DC/20/5119/FUL

Construction of a two storey rear extension.

175 Grange Road
Felixstowe
IP11 2PZ

EASTSUFFOLK
C O U N C I L

Proposed Elevations

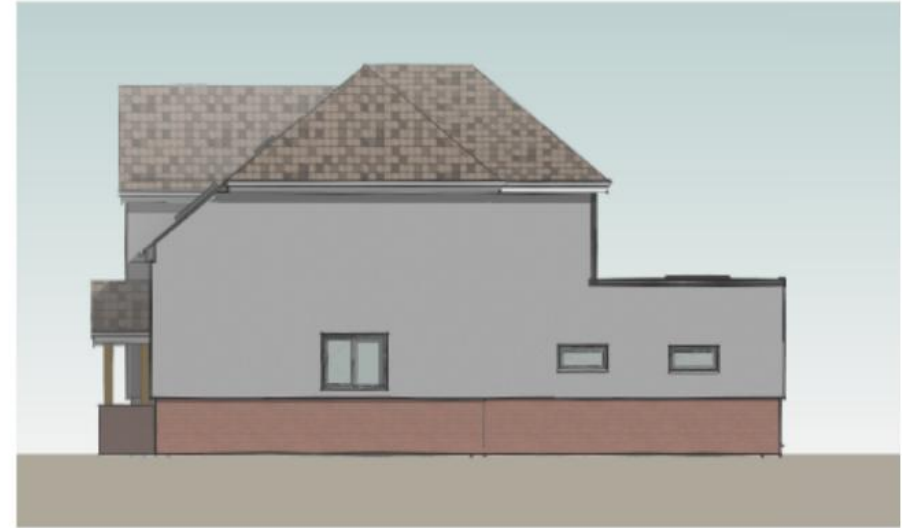
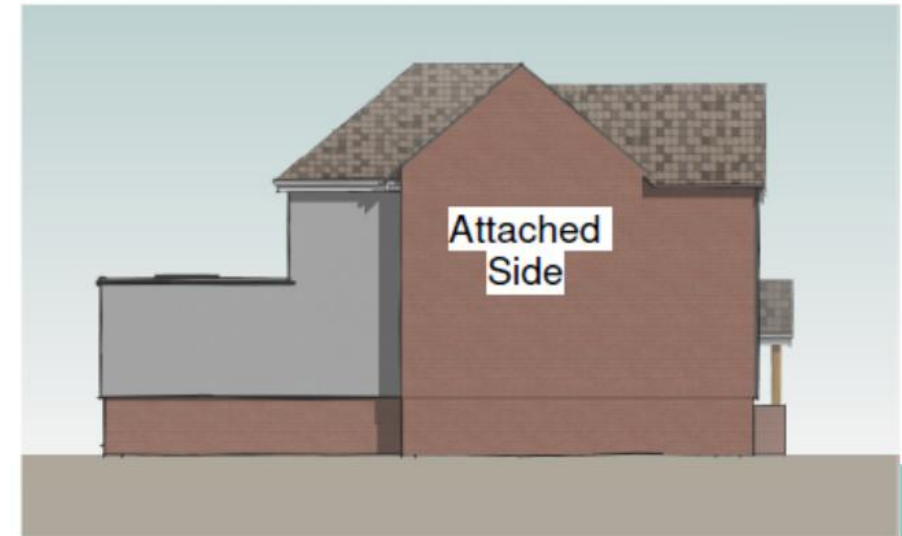
“Committee recommended REFUSAL. The proposed cladding materials would be incongruous with the local character and distinctiveness of this and the neighbouring dwellings, contrary to SCLP 11.1(b). The proposals would also lead to a development that is not in keeping with the scale and character of the building within the surroundings, contrary to SCLP 11.1(c)iii in relation to height and massing and SCLP 11.2 (e) in respect of its physical relationship with other properties.

We are also concerned about the impact on the access to daylight and sunlight to neighbour's bedroom window, with reference to SCLP11.2(c) and SPG 16.”
